**PETITION OF NATIONAL GRID, LOCATION OF RECTIFIER**

**Subject: National Grid – Rectifier Petition – 33 Ethan Allen Drive**

PROPOSED RECTIFIER AND  
GROUNDED INSTALLATION  
(40-5 RECTIFIER)

**Figure 4 – Proposed Location for the Anode Rods within the Ticonderoga Road R.O.W. next to 35 Ethan Allen Drive**

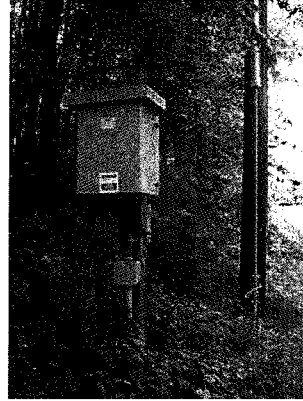
1. There appears to be a drain pipe entering into the catch basin in the same general vicinity as the rectifier approximately 4.5' below ground level. National Grid needs to take the necessary precautions to avoid damaging this drain line.

2. The abutter at 35 Ethan Allen Drive may have a drain pipe entering the catch basin within the Ticonderoga Road right of way in the same vicinity as the proposed anodes. National Grid needs to take the necessary precautions to avoid damaging this drain line during the installation of the anodes and the associated wiring. We recommend that National Grid contact the abutter at 35 Ethan Allen Drive to ensure there are no other issues with the proposed anode bed.

3. This proposed work is also in the same general vicinity as some road bounds marking the edge of the layouts for Ethan Allen Drive and Ticonderoga Road. We are concerned that these points may be disturbed and/or destroyed during construction. These monuments should be labeled on the plan along with a note to locate/mark these points in the field prior to construction. There should also be a condition that if these survey markers are damaged or destroyed during construction that the applicant will hire a registered land surveyor to reset the monuments and certify the new locations.

4. National Grid was required by the Board of Selectmen to present these projects to the Design Review Board for their review and comments. We sent the attached list to National Grid to describe the steps they need to follow in order to obtain permission from the Board of Selectmen for a new rectifier pole installation.
5. It appears that the homeowner at this location has a fence and some plantings in the same location as the rectifier. These features are not shown on the plan and we are not sure how they will be handled and/or relocated.
